## **Technical Bulletin**

SERVICE BULLETIN							
Classification:	Reference:	Date:					
EC16-034	NTB17-082	July 21, 2017

# NISSAN; DTC P0456 CAUSED BY EVAP LEAK AT VENT CONTROL VALVE O-RING

**Vent control valve**

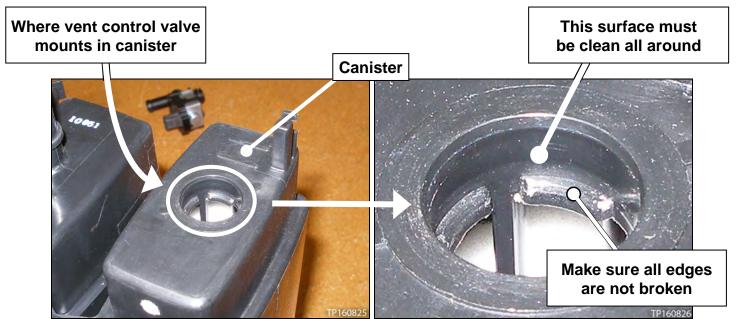
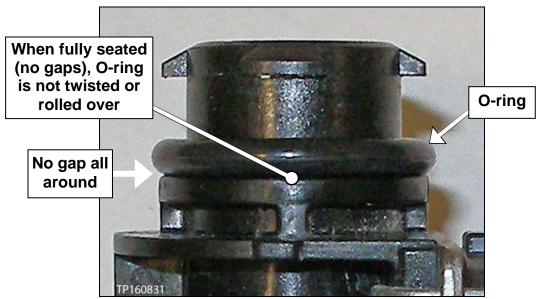
- 1. Replace the O-ring.
  - To access the O-ring, refer to the appropriate section in the Electronic Service Manual (ESM) of the APPLIED VEHICLE for vent control valve removal and installation.
  - This O-ring is now available separately (see PARTS INFORMATION).
  - When installing, do not add any lubrication to the O-ring.
  - Seat the O-ring all the way down as shown on page 4, Figure 7.
    - Having the O-ring seated all the way down will assure it is not twisted or rolled over.
  - Refer to the pictures on pages 3 and 4 for additional installation information.

- Make sure the surfaces that the O-ring comes in contact with are clean.
- When installed, make sure the O-ring is not twisted or rolled over.
- Verify the repair is complete by checking for leaks with a "smoke" leak detection machine or CONSULT-III plus (C-III plus).
  - If a "smoke" leak detection machine is used, follow the manufacturer's operating instructions.
  - ➤ If C-III plus is used:
    - 1. Confirm the fuel filler cap is secure.
    - 2. Connect Essential Tool J-42909 to the EVAP service port.
    - 3. Using Active Test, close the vent control valve.
    - 4. Apply pressure using J-42909 until the bar graph reaches about halfway.
    - 5. Monitor the bar graph for 10 minutes.
